Re: OPSB Case No. 19-1740-EL-BTA
Application for a First Amendment to the
Scioto Ridge Transmission Line

APPLICATION
TO THE
OHIO POWER SITING BOARD
FOR AMENDMENT TO
CERTIFICATE OF ENVIRONMENTAL COMPATIBILITY & PUBLIC NEED
FOR THE
SCIOTO RIDGE TRANSMISSION LINE
CASE NO. 19-1740-EL-BTA

BEFORE THE OHIO POWER SITING BOARD
First Amendment Application of Hardin Wind LLC
Scioto Ridge Transmission Line

Figure 05-1
Landowner Status

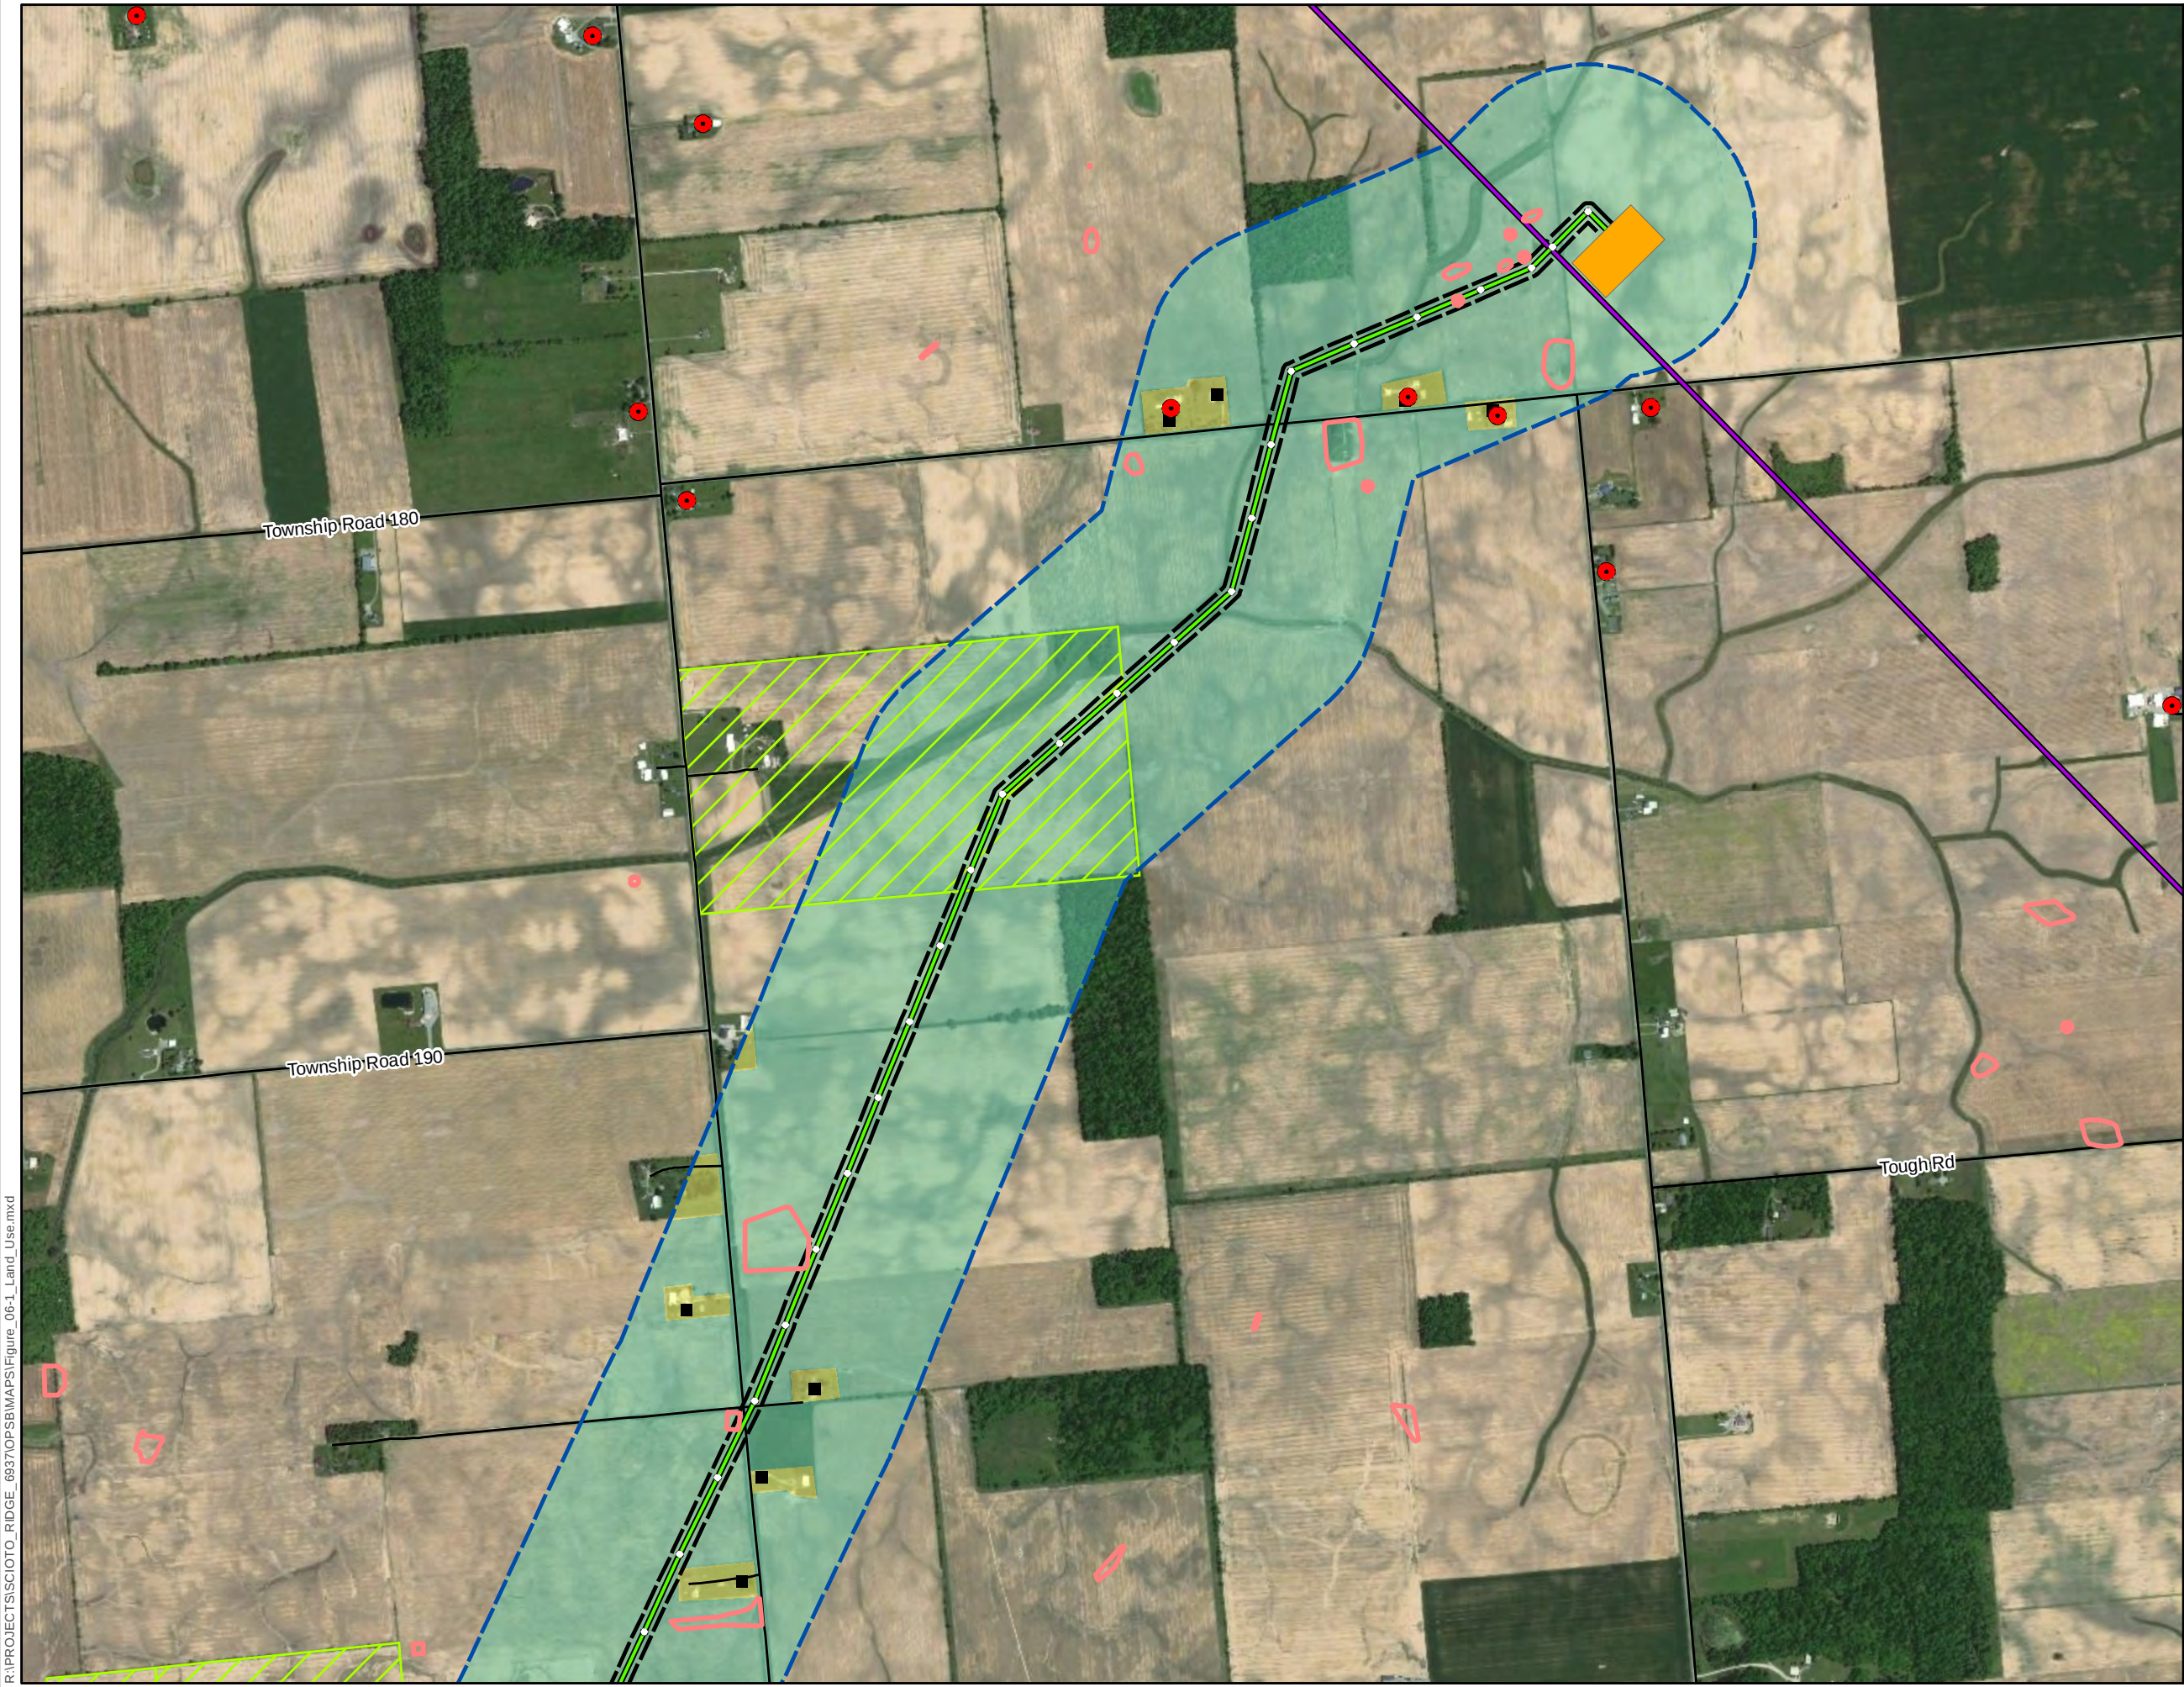
Lease agreements for all parcels along the Facility's route have been signed and will not change the ownership status of these private lands. As shown in Figure 05-1, all parcels within the Facility's route are participating. Limited portions of the Facility will span public transportation ROWs; however, the Facility will not change the ownership status of such ROWs.

Revised Figure 06-1 Land Use

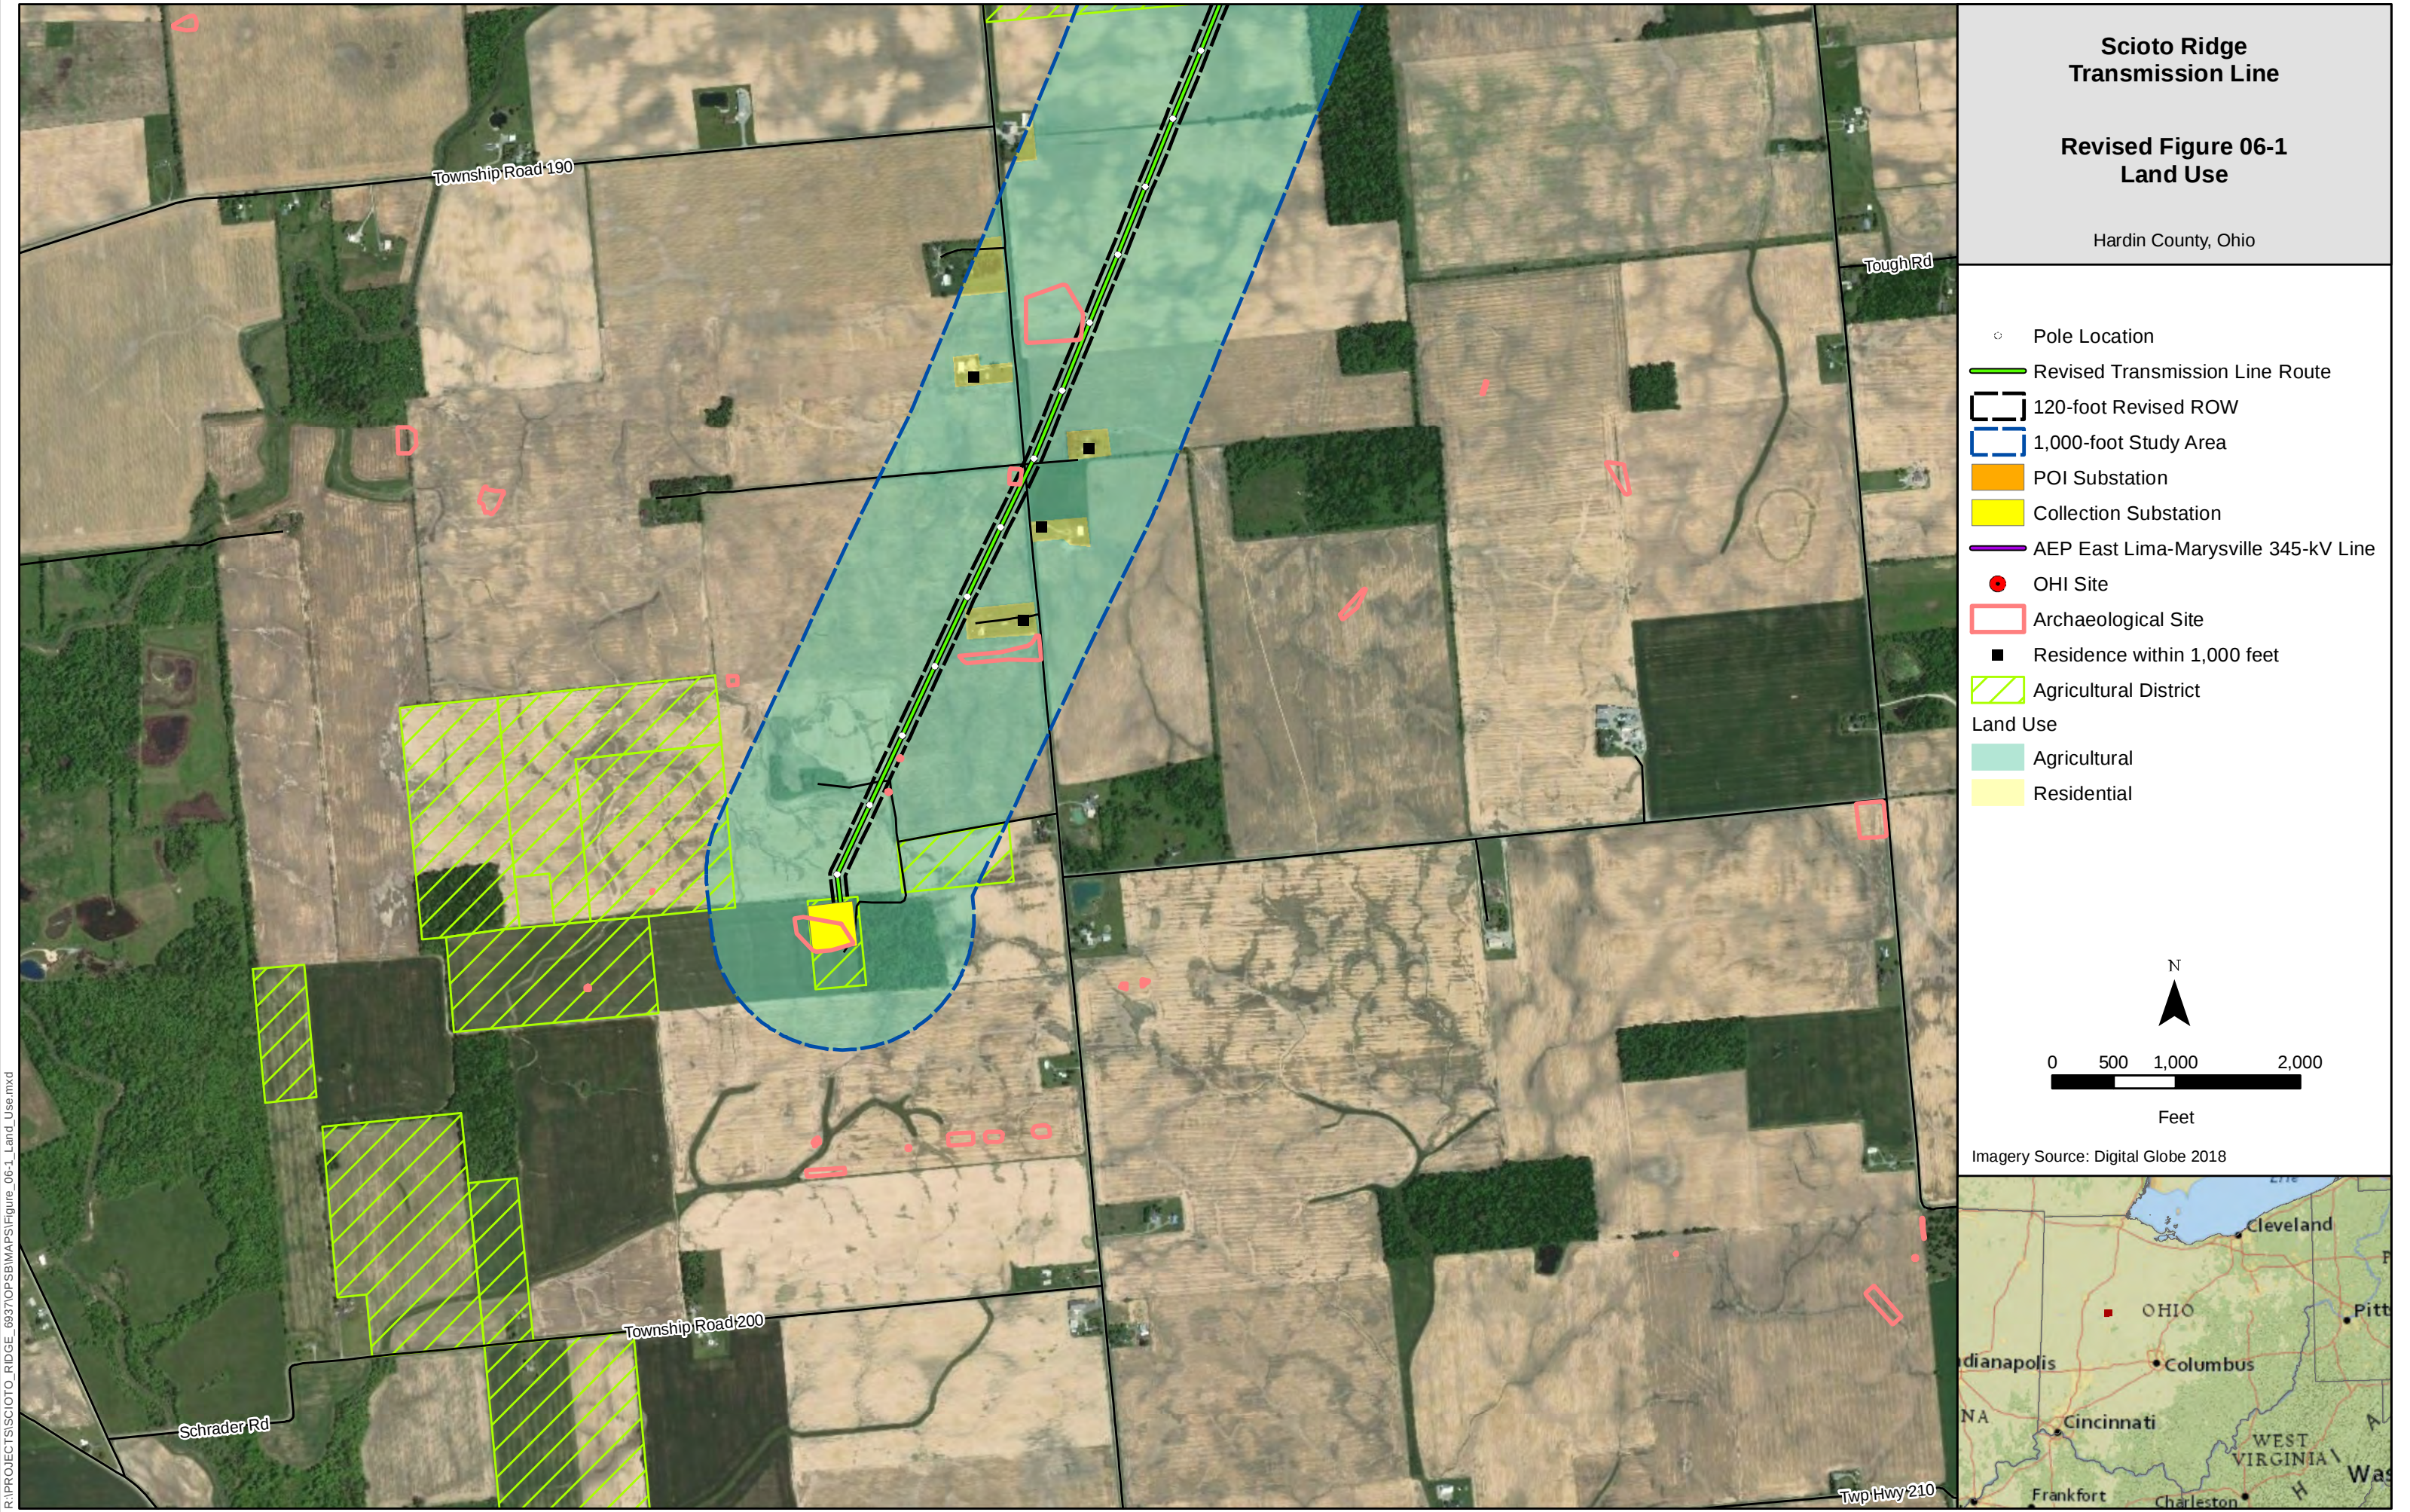
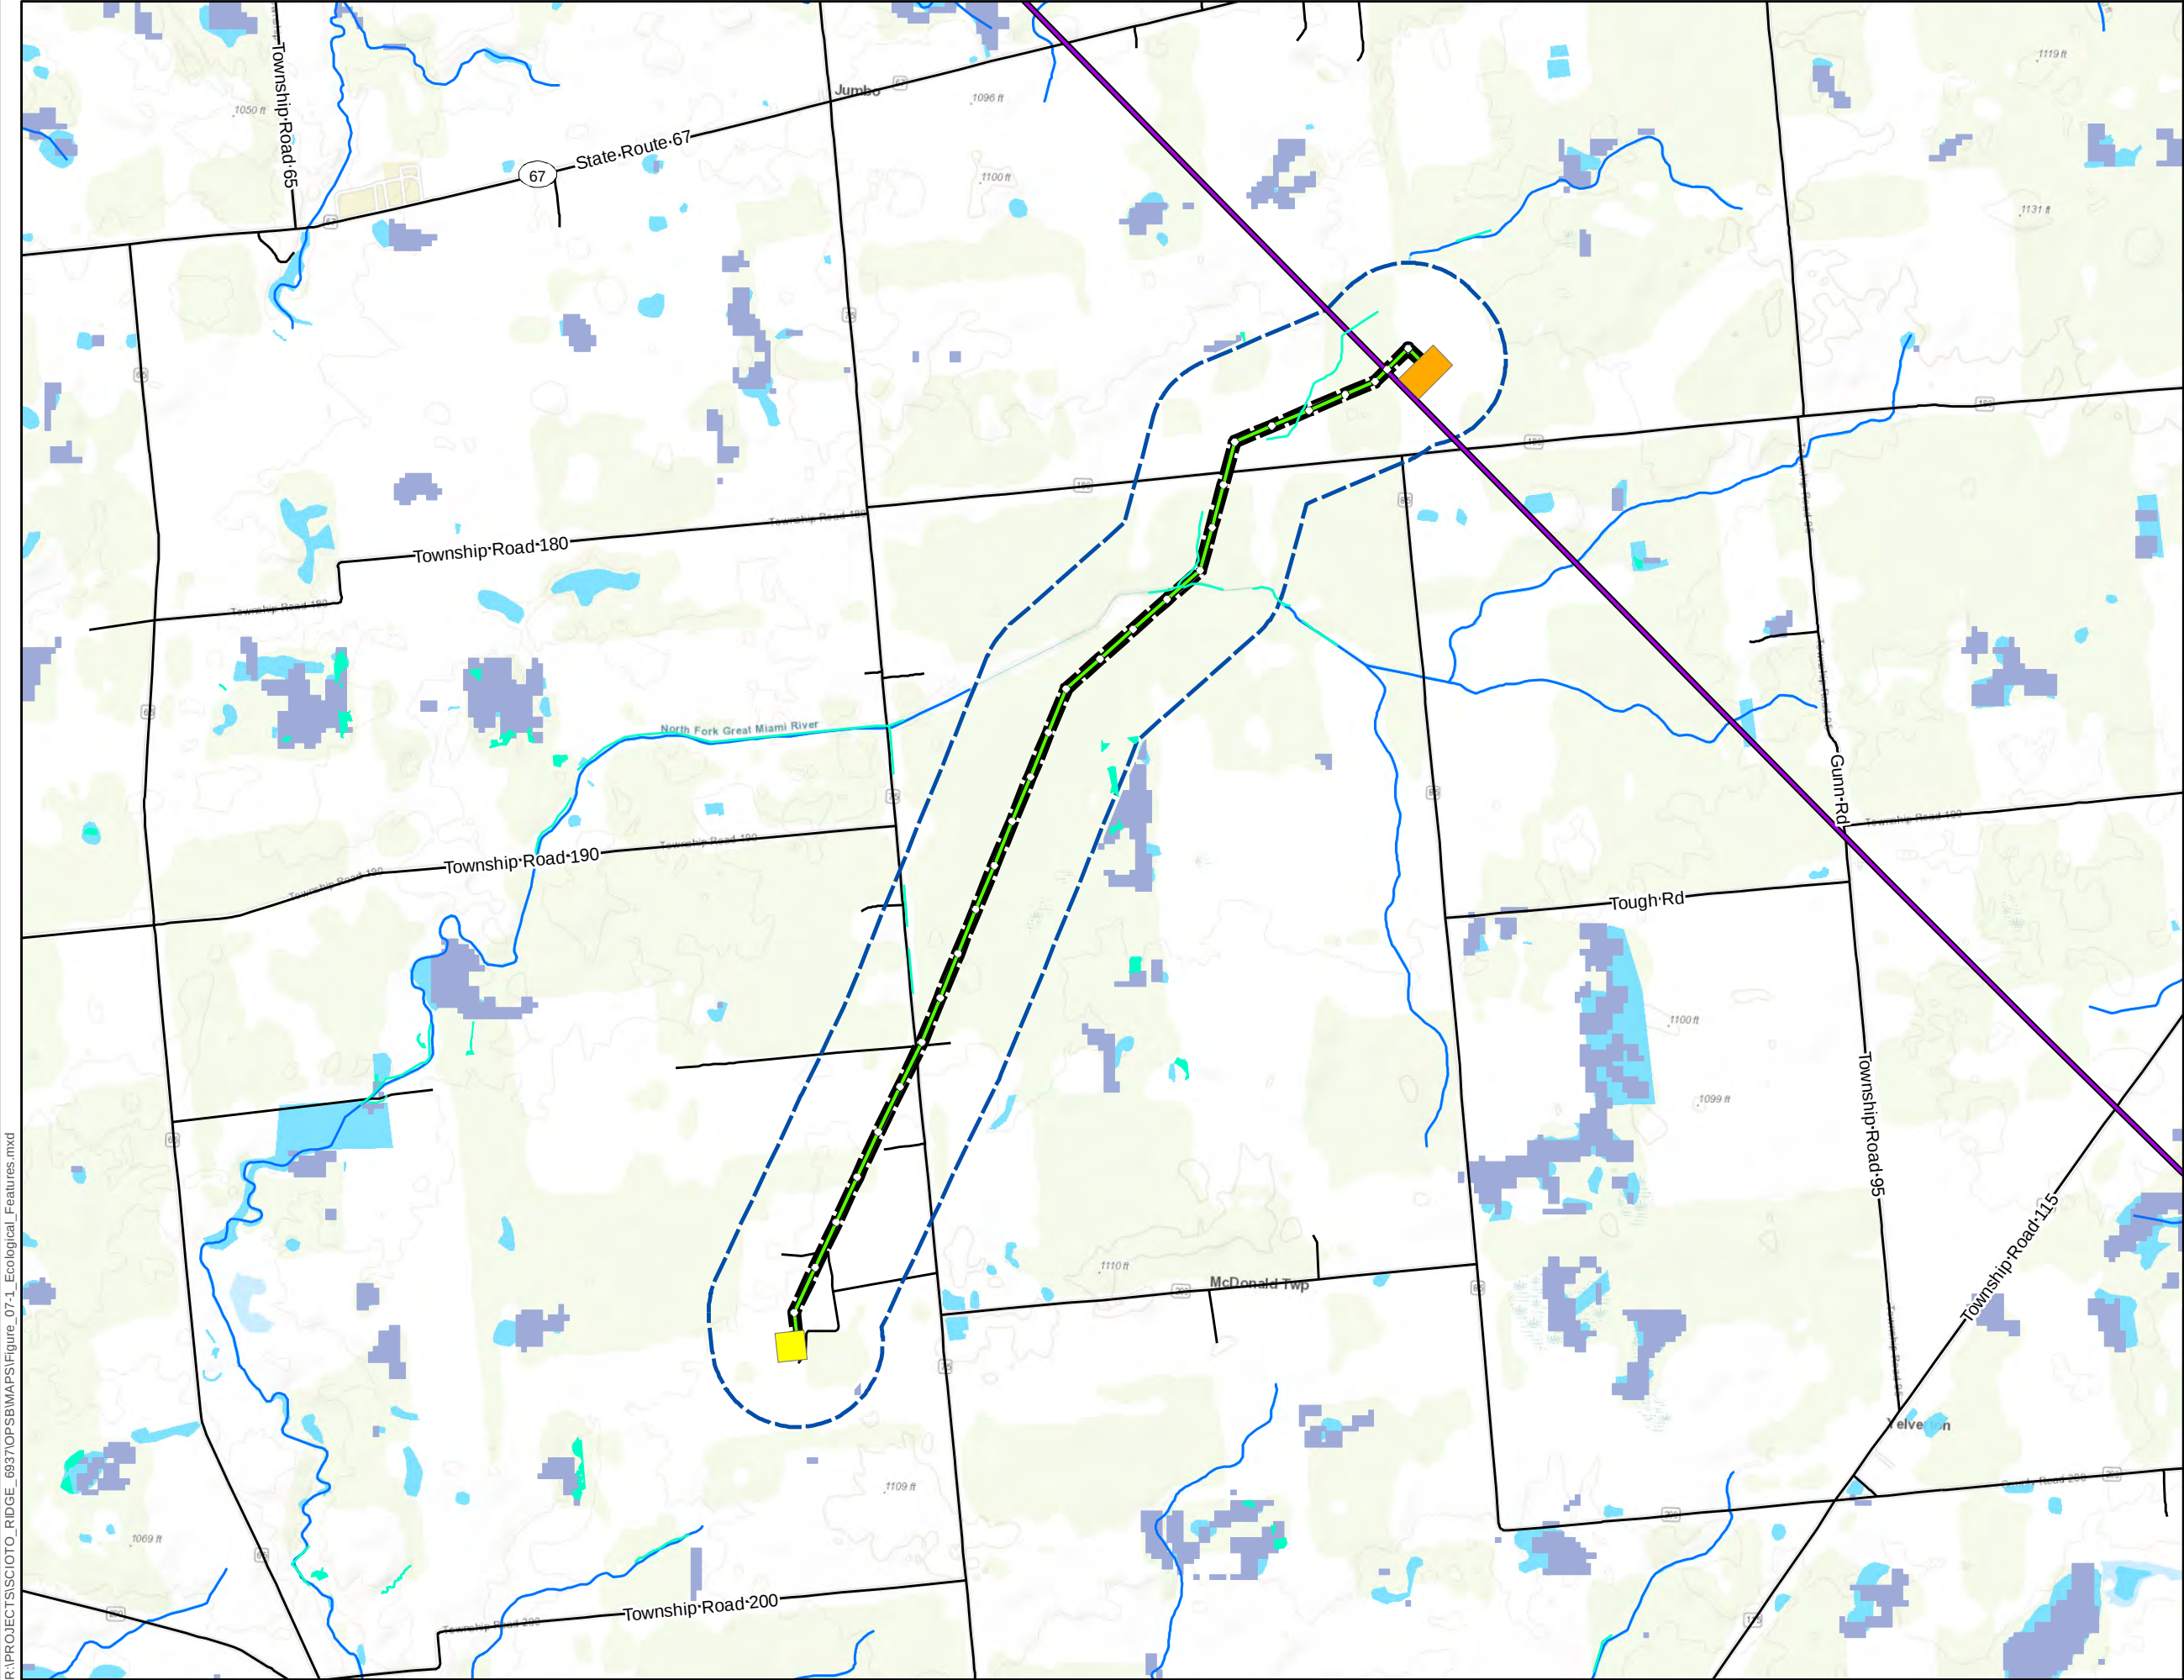
Revised Figure 06-1 illustrates the area 1,000 feet to all sides of the revised Facility route at a 1:14,000 scale.

As shown on Revised Figure 06-1, there are eight residential structures within 1,000 feet of the revised Facility route, including two participating landowners and six non-participating landowners. There are no residential structures within 100 feet of the revised Facility route.
